CONDITIONAL USE PLAN

LAND DEVELOPMENT FOR  
**THE MALVERN SCHOOL**

Re: Malvern School Conditional Use Plan  
Westtown Township  
EBWA No. 4432

### **McCormick Taylor Review Comments**

**CONDITIONAL USE  
FIRE TRUCK TURNING PLAN**

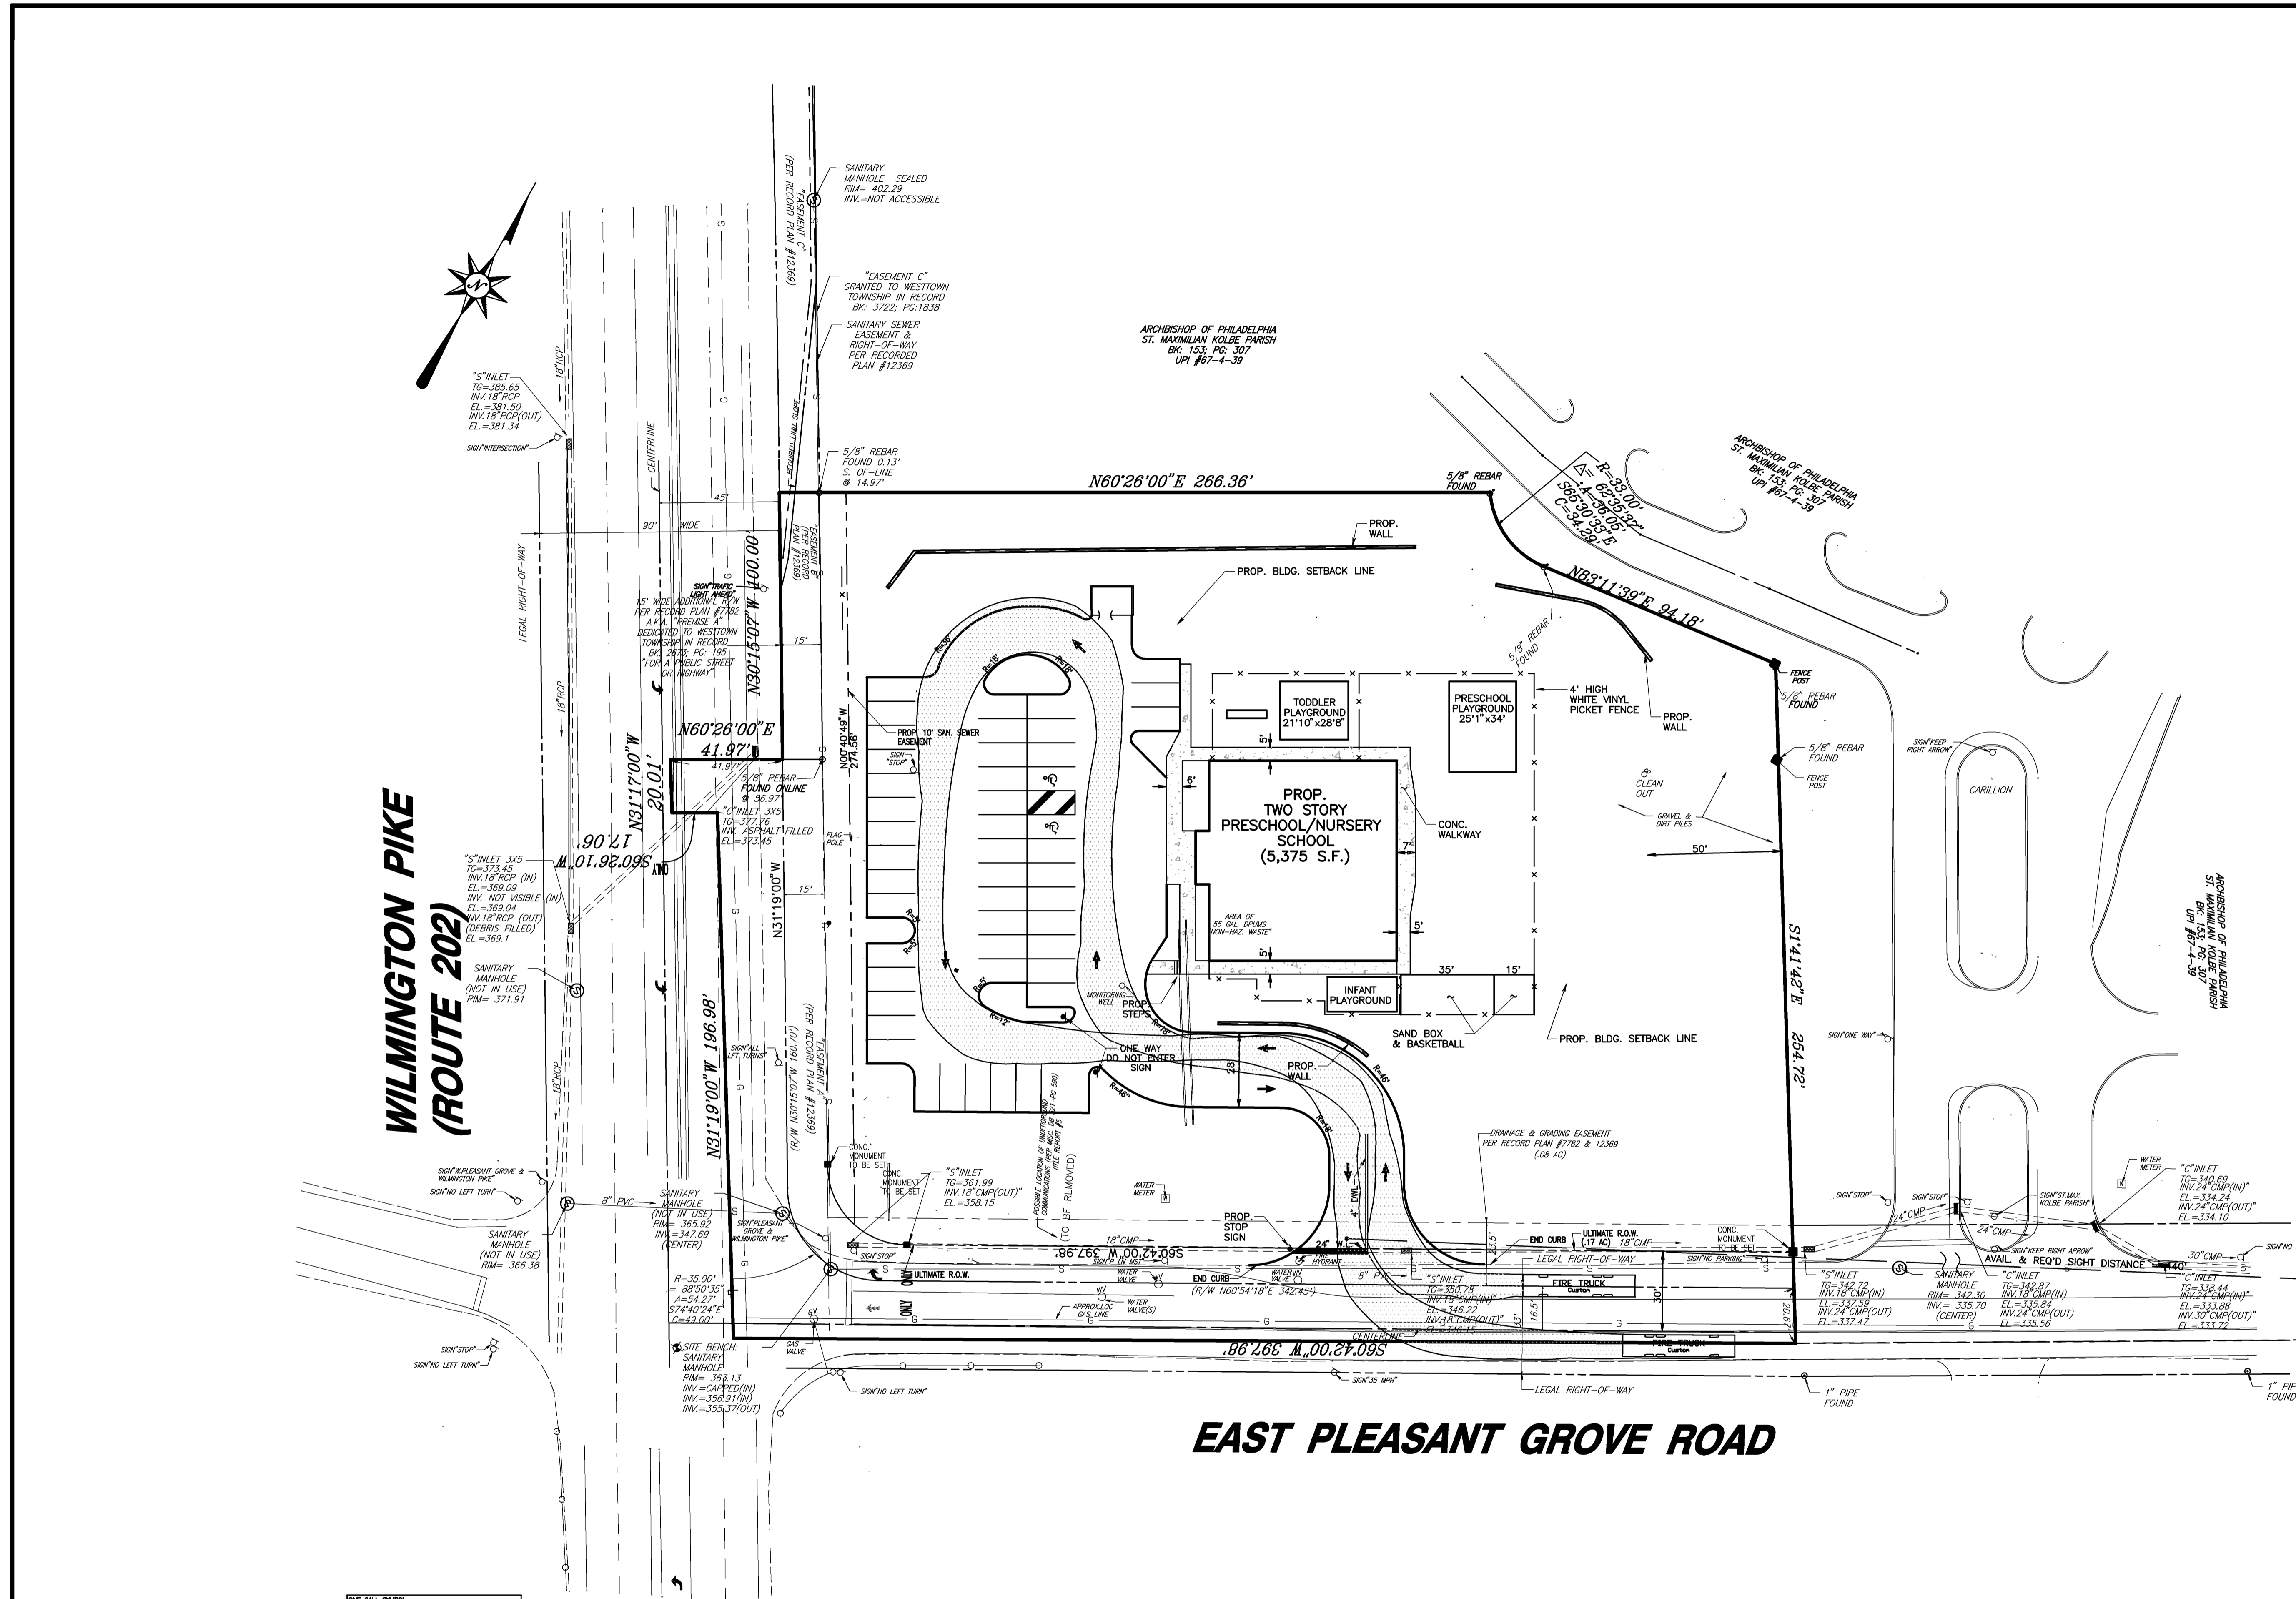
4. LEED design principles will be discussed and provided by others.
5. The tree removal and existing features/conservation plan can be found on sheet 2.
6. The subject property was previously approved for a 30,000 s.f. Office building that had sewer and water capacity the sewer capacity and water capacity availability has not changed since the prior approval. There is no reason to believe that the current proposal would not have adequate services. Therefore, we believe that we have met this requirement and that during Land Development the specific approvals and details will be worked out. With regard to Emergency services it is in my client's best interest to coordinate with the Emergency services providers and they will do so during the Land Development approval process. Lastly we have added a Fire Truck turning template plan to the plan set.
